SITE: Land to the north of Hedgerow Way, Holmer, Hereford, Herefordshire HR4 9RG
TYPE: Planning Permission
DESCRIPTION: Proposed erection of 105 dwellings alongside access, and associated infrastructure including the widening of the northern footpath to 3 metres along Hedgerow Way.
APPLICATION NO: 224270
GRID REFERENCE: OS 350110, 242493
APPLICANT: Bloor Homes Western
AGENT: Mr Guy Wakefield

Our knowledge of the development proposals has been obtained from the additional sources following our initial consultation response in April 2023:

- Attenuation Basin As Built (Rev A);
- Planning Engineering (Rev D).

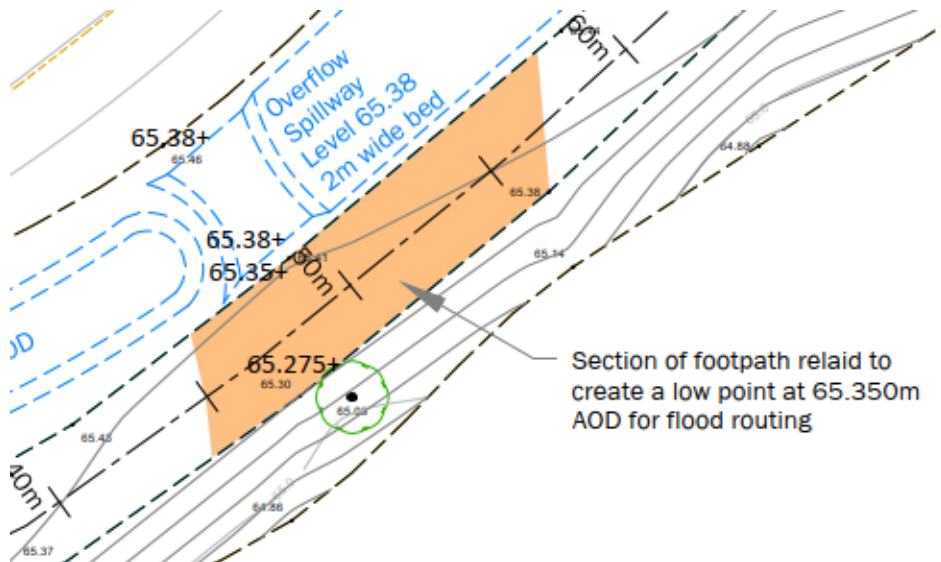
The assessment assumes a 40% increase in rainfall due to climate change. We note that the current requirements for Herefordshire are based on an upper end increase are 45% for 2070 and beyond for a 1 in a 100 year event.

Our previous advice regarding the Holmer West application was based on the earlier projections of climate change. The Outline Planning application 150478 was approved on the basis of 30% climate change.

The simulations show water spilling over the raised weir (level 65.250m). However, the as-built level of the cycleway is 65.410m. Accordingly additional water will be attenuated in the pond and the volumetric criteria will be met.

As there is additional capacity in the pond and the simulated climate change is above 30%, we accept the proposals to raise the weir. We also note that as the Applicant has provided a detailed
